# SERVICE BULLETIN #123

04/14/14

## 3560 Spoke Wheel

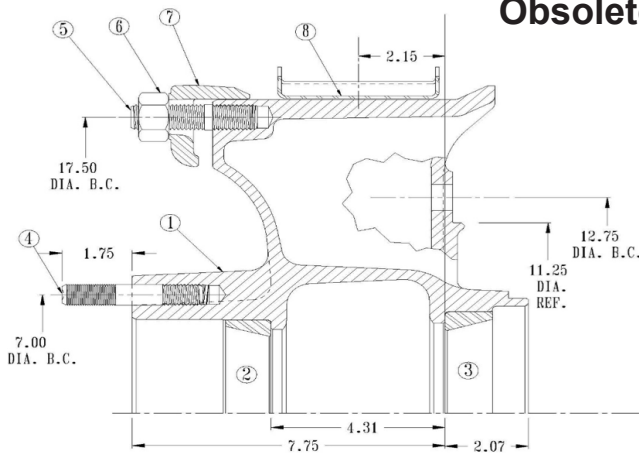
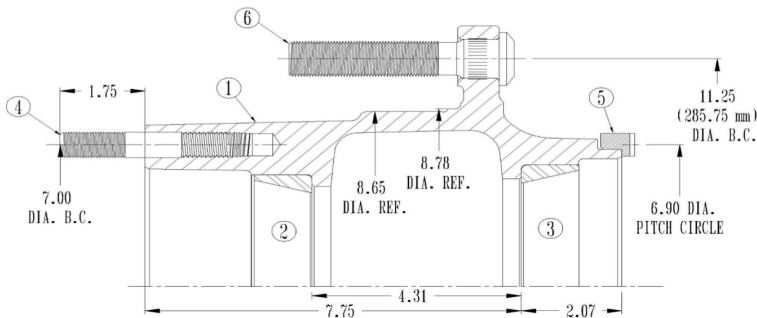
Upon depletion of inventory, the 3560 spoke will become obsolete with no direct replacement. We do however recommend a replacement: the 10-stud 2643 hub. This requires changing brake drums, changing to a disc hub, and changing to disc wheels instead of demountable rims. If you have any questions, please contact the Webb Engineering department via email to [engineering@webbwheel.com](mailto:engineering@webbwheel.com) or call 256-736-6356.

### Replacement Option
